Description of Project: Const of New Mechanic's Shop - P4 - CO#1

1. AI-82551 Requesting approval of Change Order No. 1, awarded to NM Contracting, LLC for the Construction of Pct's. 4 Mechanic Shop project to extend the term of the contract for an additional 32 calendar days as recommended by project architect ERO Architects (C-20-298-11-17). Subject to form 1295

Change Order

Sheet Number
AE102R

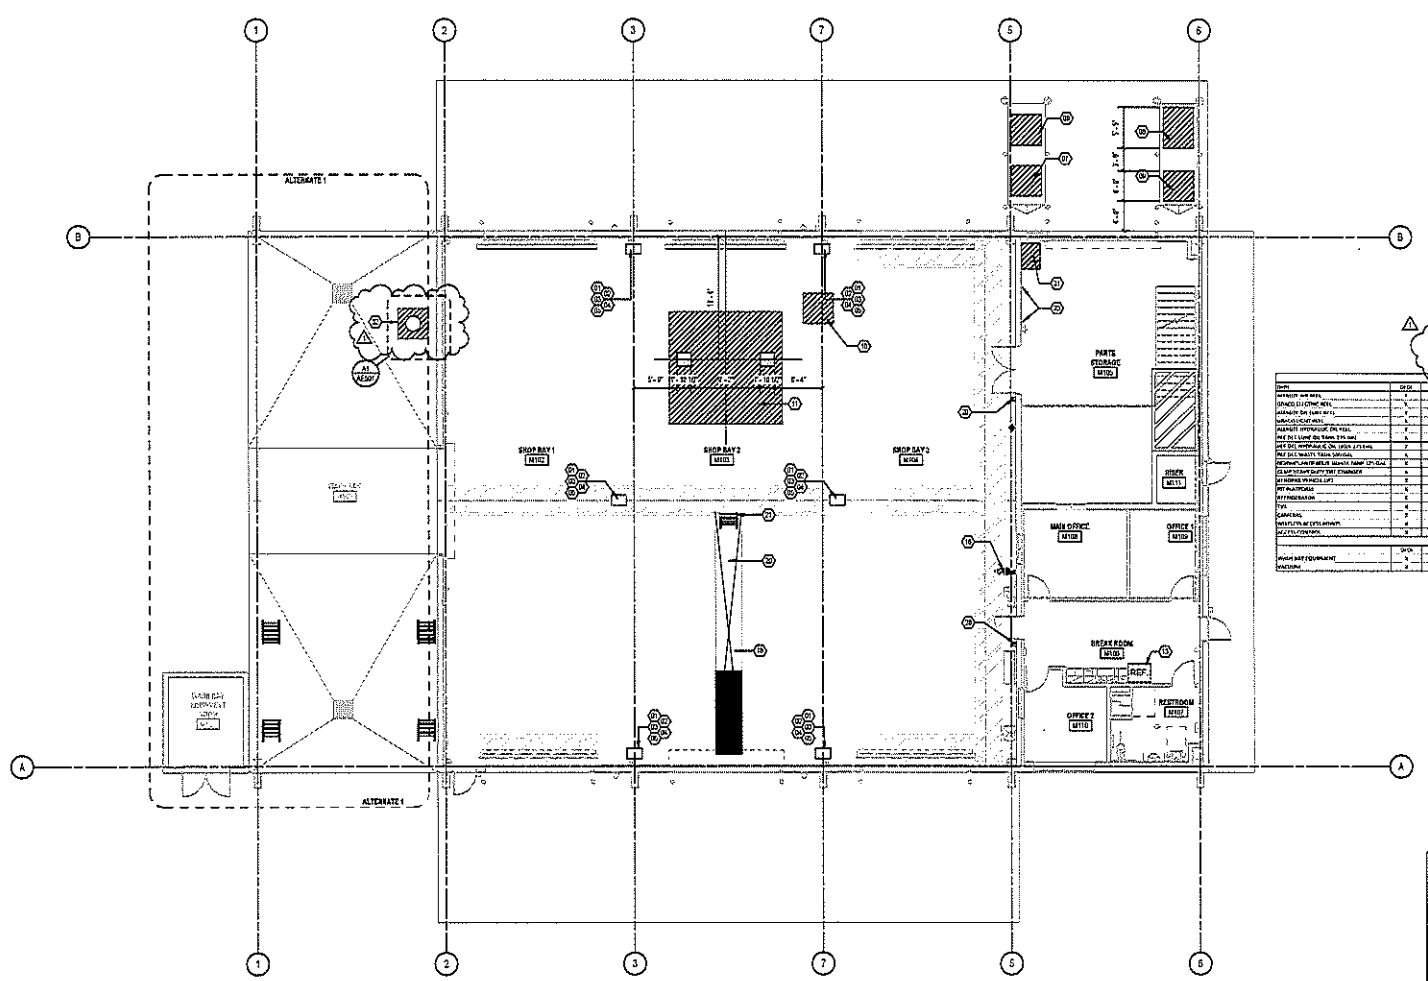
17. On sheet AE102 details C1 and A1 shows 2 ship ladders with platforms by O'Keeffe model 522 (see attachment). This model requires additional info as indicated on attachment. Provide dimensions height, width and length of ladder and platform. Provide type of metal and color if any.
ERO Response: Refer to sheets AE102R & AE301R attached.

Item No. P02. Sheet AE102 – Delete in its entirety
Replace with revised Sheet AE102R. Refer to attached.
